Final Safety Evaluation Report for the Early Site Permit Application for the Clinch River Nuclear Site

U. S. Nuclear Regulatory Commission
Office of New Reactors
Washington, DC 20555-0001

June 2019

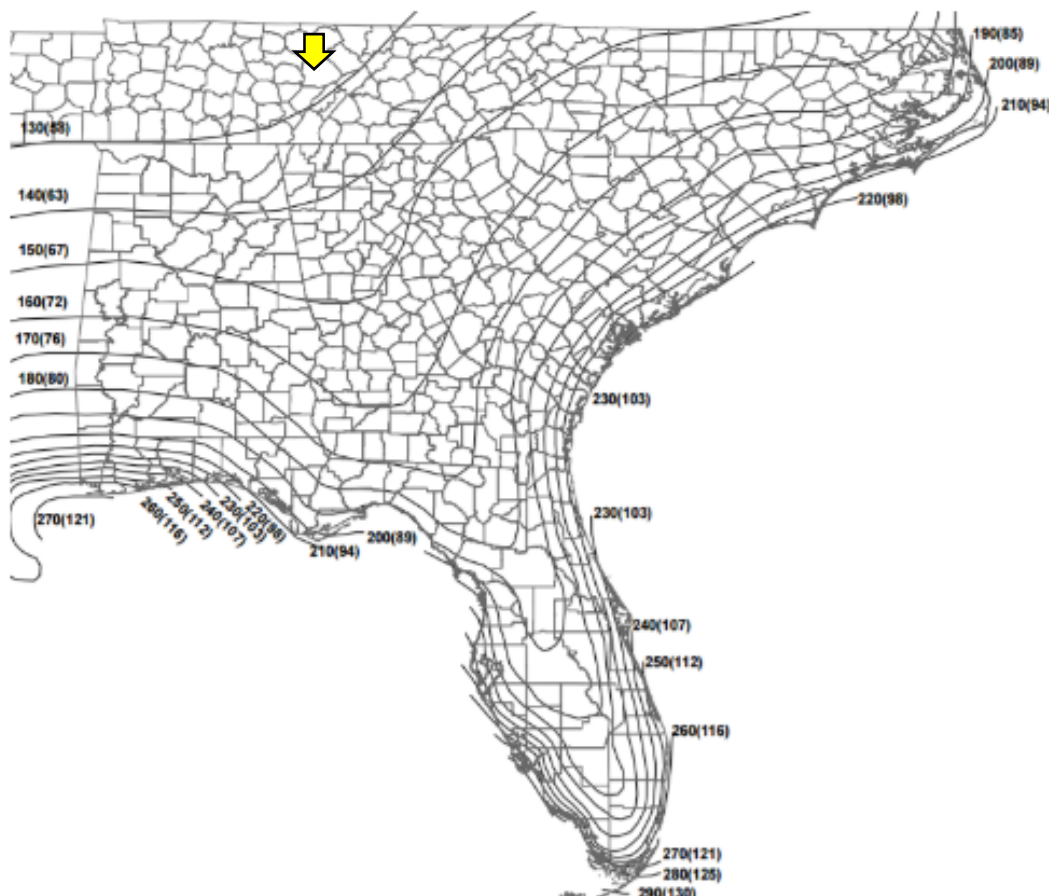
The applicant provided a site characteristic hurricane wind speed of 130 mph (3-second wind gust speed) in SSAR Table 2.0-1. Based on Figure 2.3-1, which is reproduced from RG 1.221

(NRC 2011-TN5931) and confirms applicant's site hurricane wind speed, the staff agrees with the applicant's conclusion and finds this information acceptable.

Figure 2.3-2 Effluent Release Zones with Analytical EABs

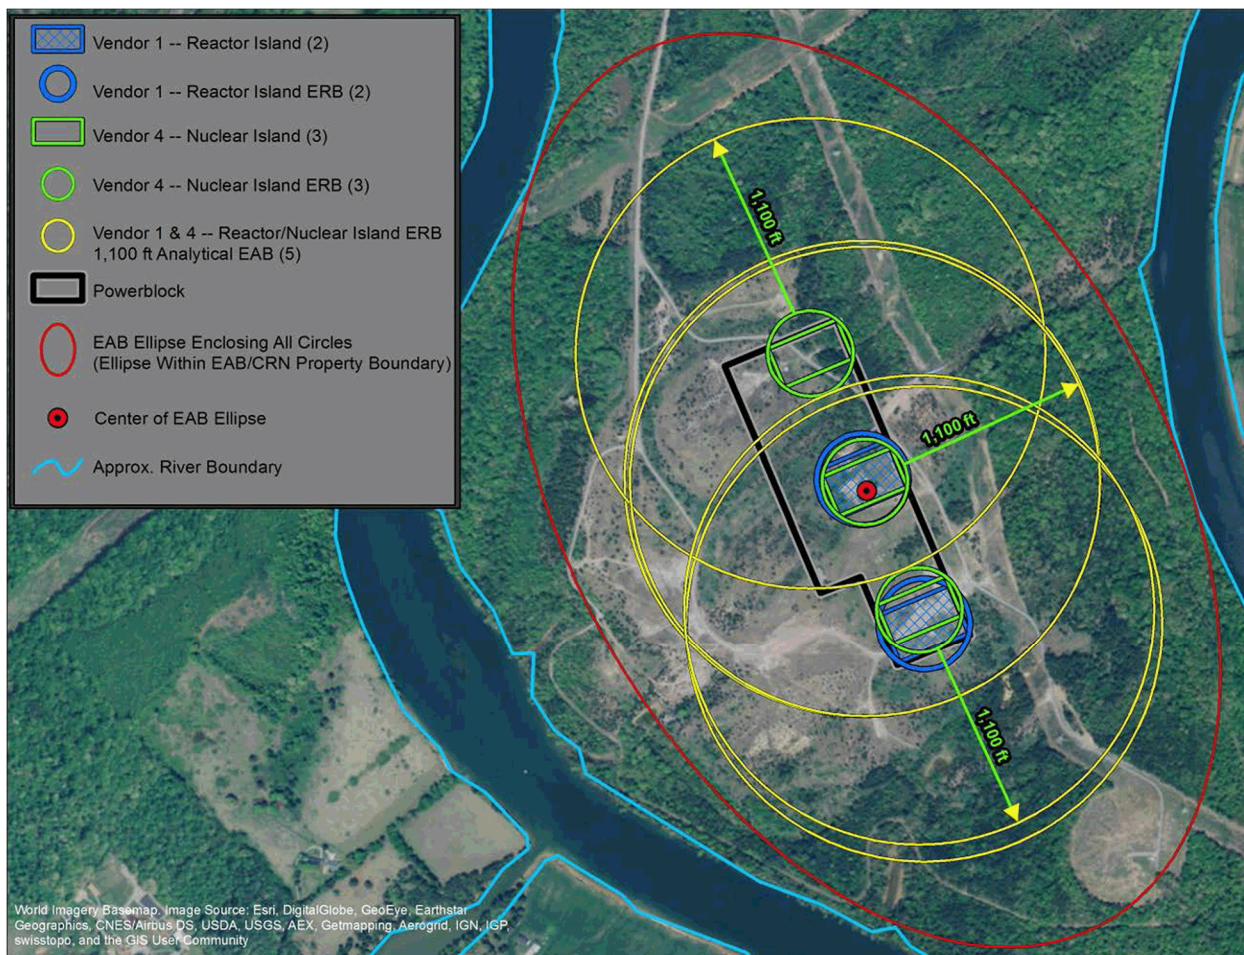
the EAB and LPZ in the 16 Wind Direction Sectors,” and SSAR Figure 2.3.4-1 (reproduced below as Figure 2.3-2) (TVA 2017-TN5387). To account for the potential for multiple units on the site, nuclear islands are positioned at multiple locations within the power block area with associated ERBs and EABs, as shown in Figure 2.3-2 below. A circular analytical EAB is established 335 m (1,100 ft) from the ERB. All of the potential nuclear island sites are bounded by the ellipse shown below that encompasses all of the analytical EAB and is completely contained within the CRN Site. Because the distance from the outer edge of the power block to the EAB is less than the actual distance from the nuclear island to the EAB, and would result in higher (more conservative) χ/Q values, the staff considers the assumptions in the dispersion analysis to be reasonable.

Figure 2.4.12-4 Hydrograph of OW-417 Well Pair (top) and, (bottom) Hydrologic Cross Section through the Clinch River, OW-417, OW-418, OW-202, and OW-423 from Left to Right (reproduced from Figures 2.4.12-29 and 2.4.12-32 [TVA 2017-TN5387]).

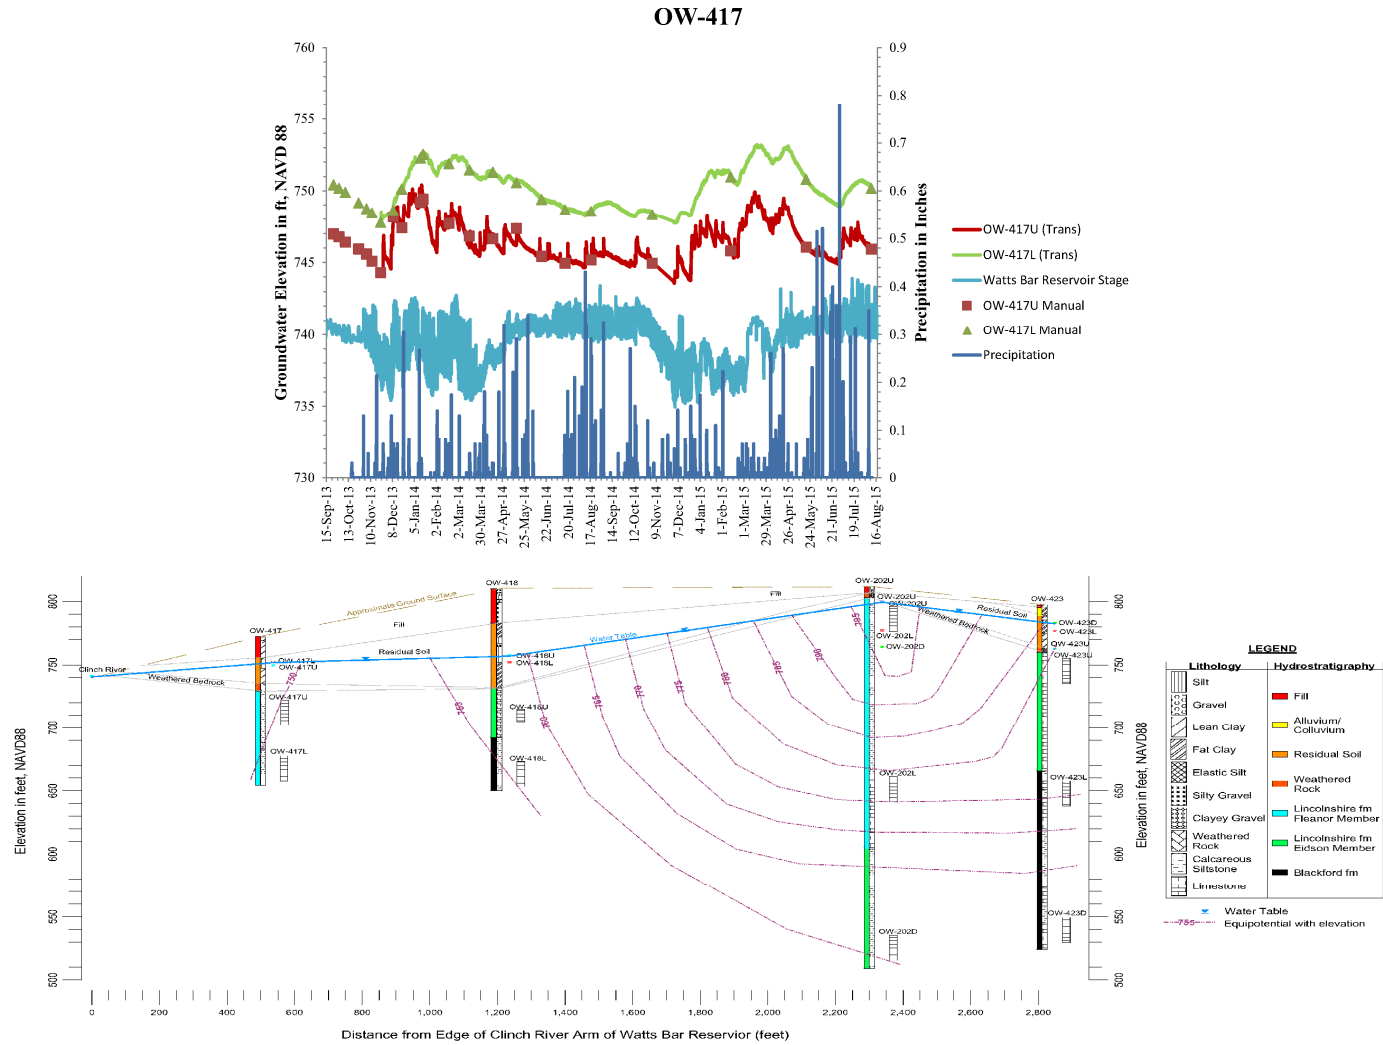
During the monitoring period (September 2013 to August 2015), groundwater gradients from OW-417 U/L were consistently upward at this well pair, which is adjacent to the Clinch River. The upward groundwater gradient (Figure 2.4.12-4) exhibited no observable correlation with the Clinch River stage over the monitoring period, indicating steady-state conditions. The consistent downward gradients in the upland areas of the site suggest precipitation recharge areas (e.g., at OW-202U/L/D well cluster) and upward hydraulic gradients near the Clinch River (e.g., at OW-417U/L); this indicates that the Clinch River acts as a discharge point for the shallow groundwater system flow from the CRN Site.

Figure 2.4.12-5 Location of Wells and Hydrologic Transects Along the Clinch River and, Cross Sections Along Transects A, B and C (after Bechtel Jacobs Company [2011-TN6169], Figures 7, 8, 9, and 10).

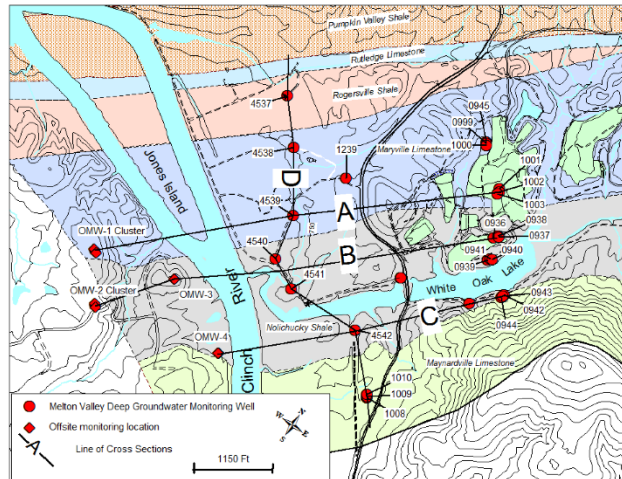
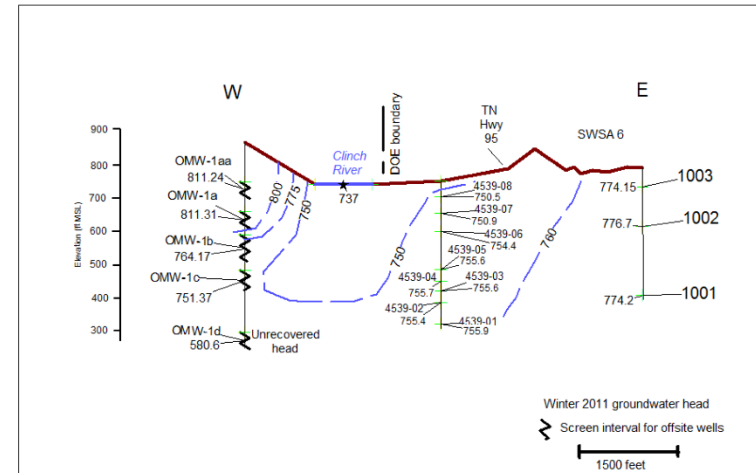
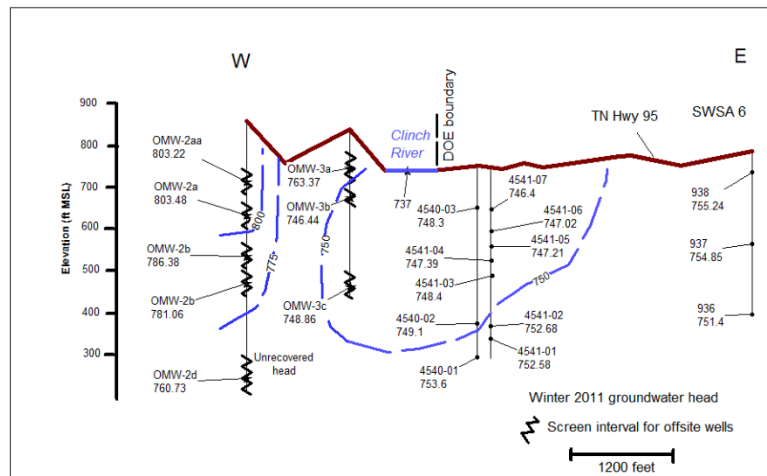
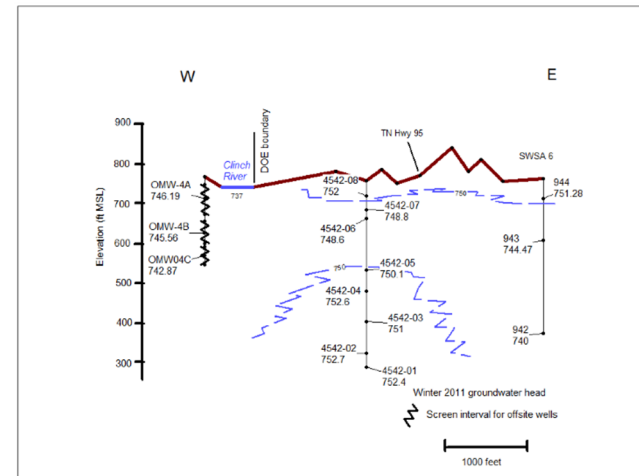
This trend is consistent with gradients near the Clinch River, as observed in studies conducted at the nearby ORR (Bechtel Jacobs Company 2011-TN6169; Dorsch and Katsube 1999-TN6036), indicating upward groundwater gradients toward the Clinch River at depth (Figure 2.4.12-5).

The applicant described precipitation as the primary source of surficial recharge to the aquifer system with minor contributions from the Clinch River during high stages. As described above, the applicant cited a study by the DOE (Bechtel Jacobs Company 2011-TN6169) indicating discharge to the Clinch River from the surrounding shallow groundwater flow system in the vicinity of the ORR (Figure 2.4.12-5) consistent with patterns on the CRN Site.

Figure 2.5.2-7 Comparison of the Applicant's Base Rock Hazard Curves with the Staff's Confirmatory Hazard Curves for the CRN Site

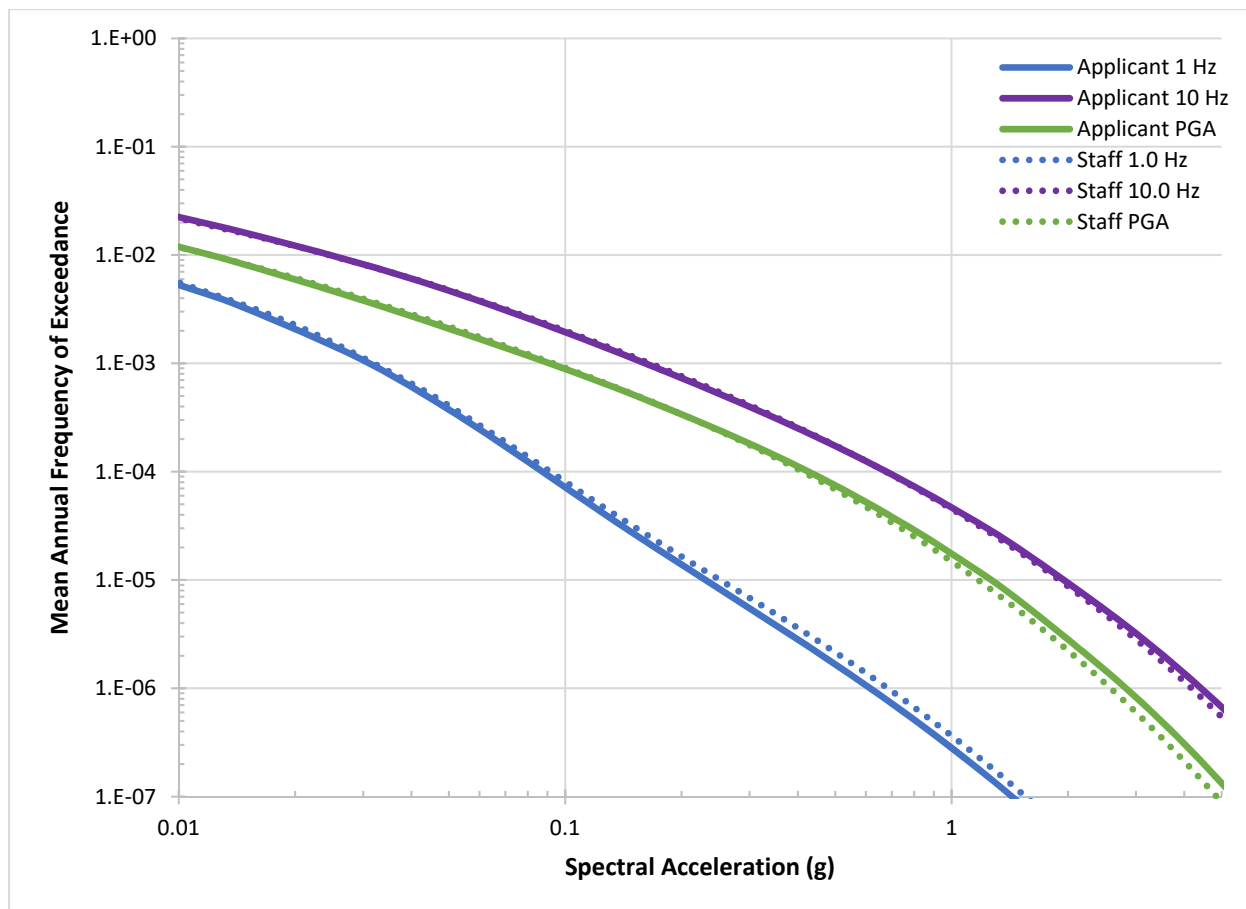
To assess the applicant's update of the recurrence parameters for the CEUS-SSC models, the staff reviewed the applicant's methodology, updated parameters, and performed its own independent confirmatory analysis, discussed in FSER Section 2.5.2.3.4.2. In considering the applicant's updated recurrence parameters, the staff reviewed the updated catalog and the applicant's maps of updated recurrence parameters (e.g., SSAR Figure 2.5.2-27 [TVA 2016-TN5018]). The updates to the recurrence parameters as a result of catalog updates are minimal and have a negligible impact on the PSHA results, as shown in Figure 2.5.2-7. Based on the staff's review and confirmatory analysis, the staff has determined that the applicant's updates are acceptable.

Figure 2.5.2-8 Comparison of the Applicant's (blue) and the Staff's Confirmatory GMRS (red) for the CRN Site. The generic hard rock ($V_s = 2.8$ km/s [9,200 fps]) GMRS (black dotted) is shown for comparison.

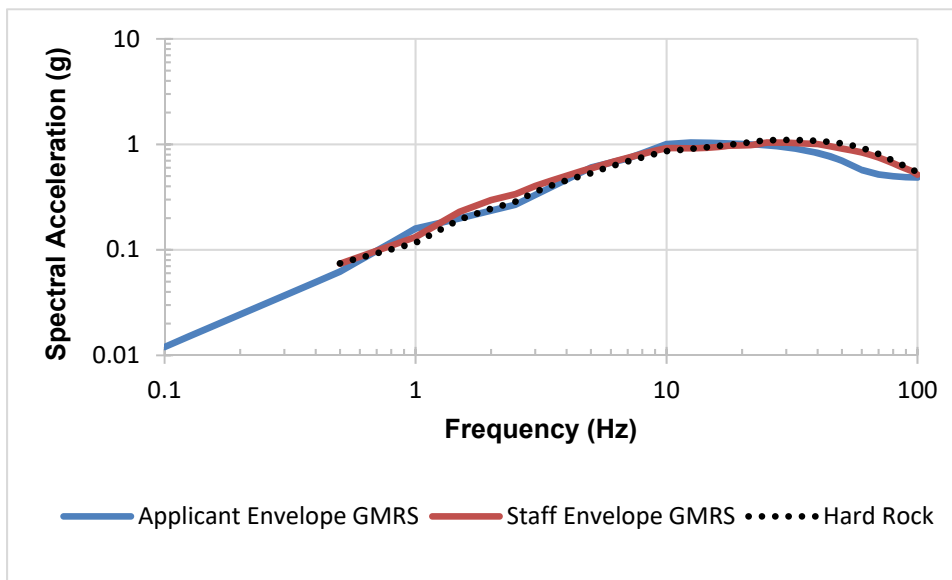
horizontal GMRS (for each spectral frequency) is obtained by scaling the 10^{-4} soil UHS by the design factor specified in RG 1.208 (NRC 2007-TN5858). A comparison of the applicant's and the staff's confirmatory horizontal GMRS is shown in Figure 2.5.2-8.
